# APPROVED MINUTES

## January 19, 2017 Standards Committee Meeting

RE: Minutes from the January 19, 2017 Standards Committee Meeting

720-CBST-06 CATCH BASIN PIPE (WITH MARKUPS)

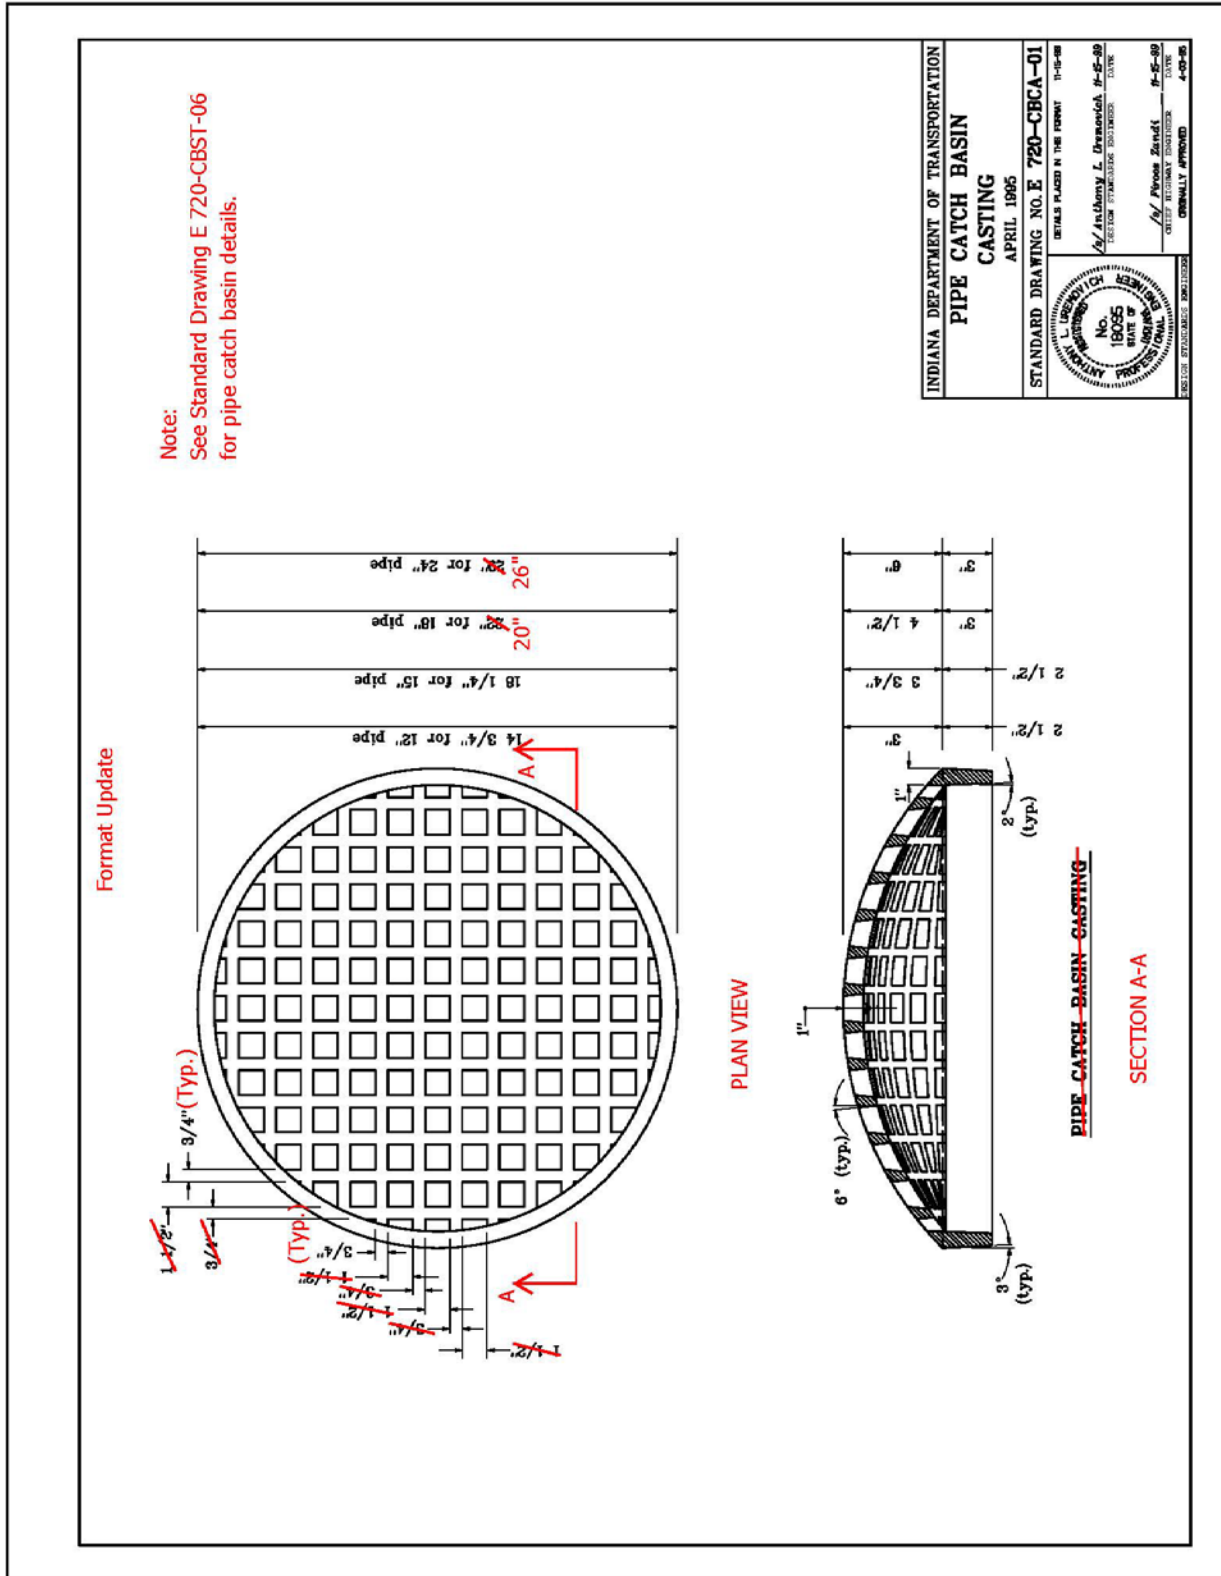
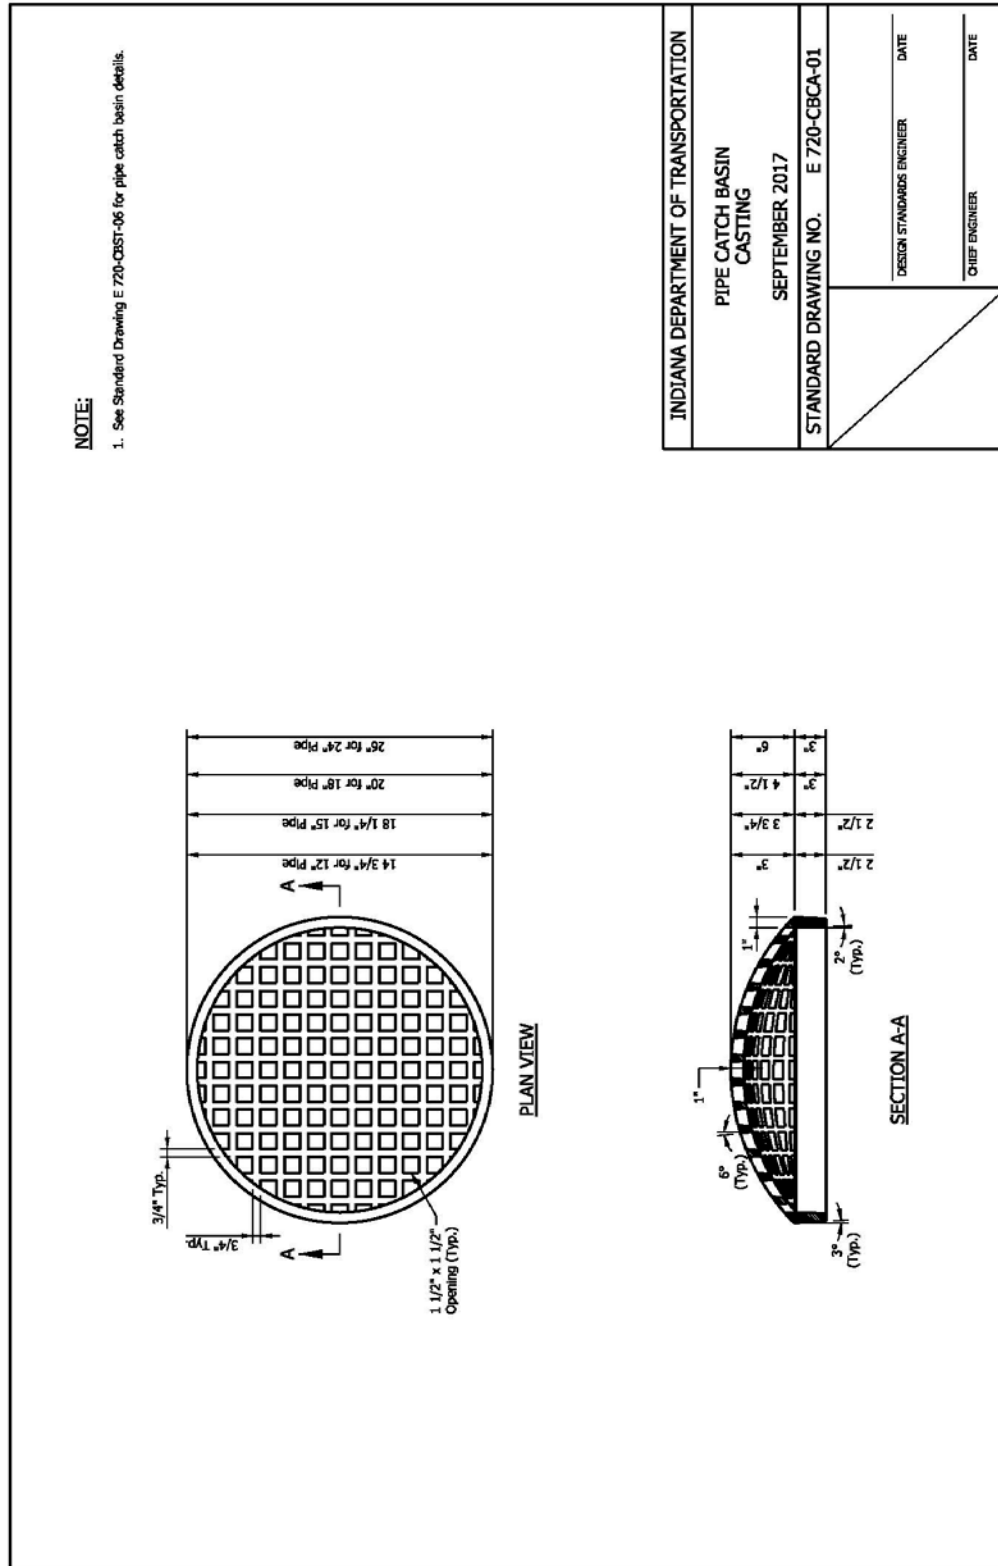
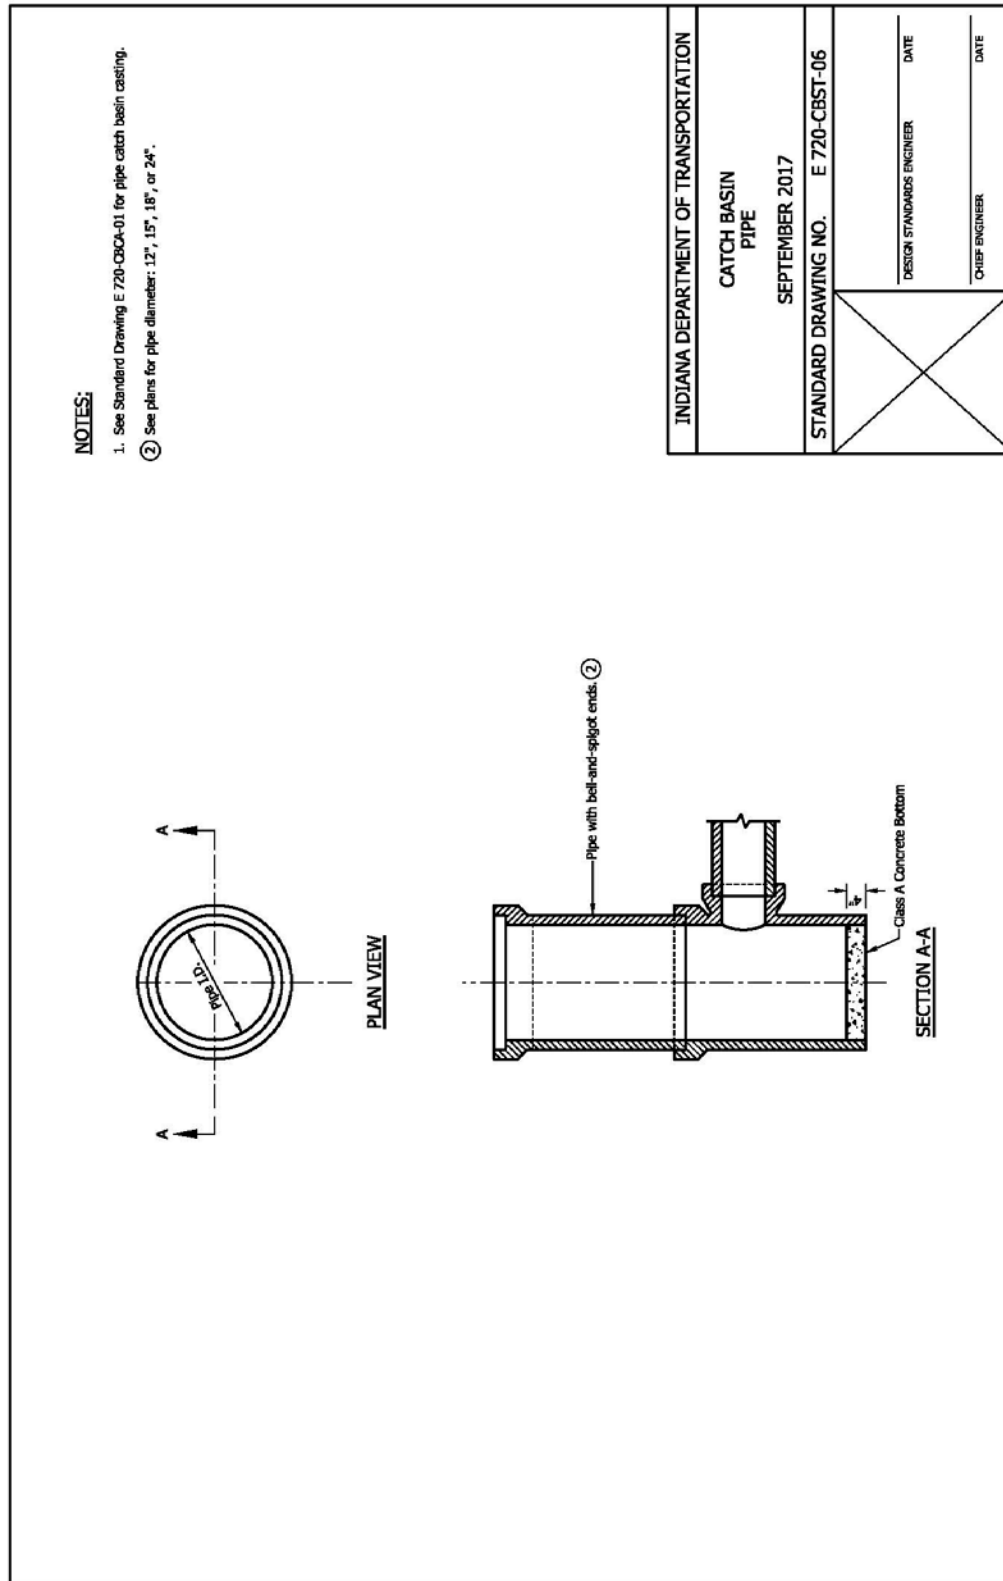
PROBLEM(S) ENCOUNTERED: Pipe basin providers are no longer making catch basin pipes with bell sizes that fit the pipe catch basin castings described in standard drawing series E720-CBCA-01.

This item was introduced and presented by Ms. Phillips who stated that pipe basin providers are no longer making catch basin pipes with bell sizes that fit the pipe catch basin castings described in standard drawing series E720-CBCA-01.
